Access Compliance Report Public Rights-of-Way (Curb Ramps)

Main Street: WINDMILL_AVE		Cross Street: SNAPDRAGON_ST		Location:	N
ADA ID: RPRK211029143901	Ramp Type: Type 4 - Parallel	Initial Pass/Fail: Fail	Overall Compliance: No	Severity Score:	30

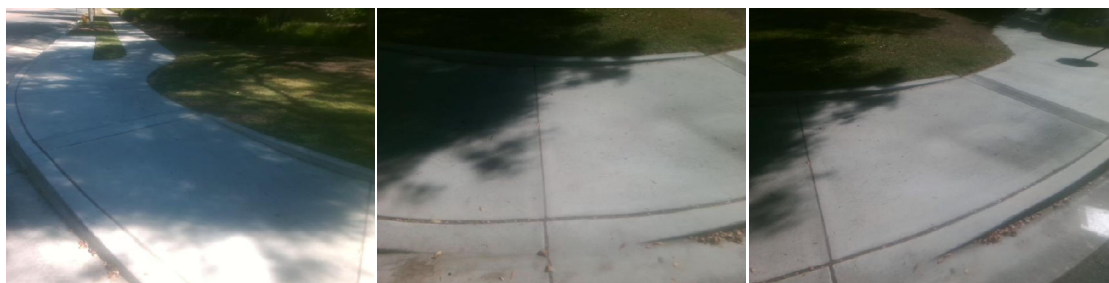
R204.3, R304.3.2, R304.5.3, STD 1115

Remove & Replace Curb Ramp With Two New Directional Ramps or Equivalent.
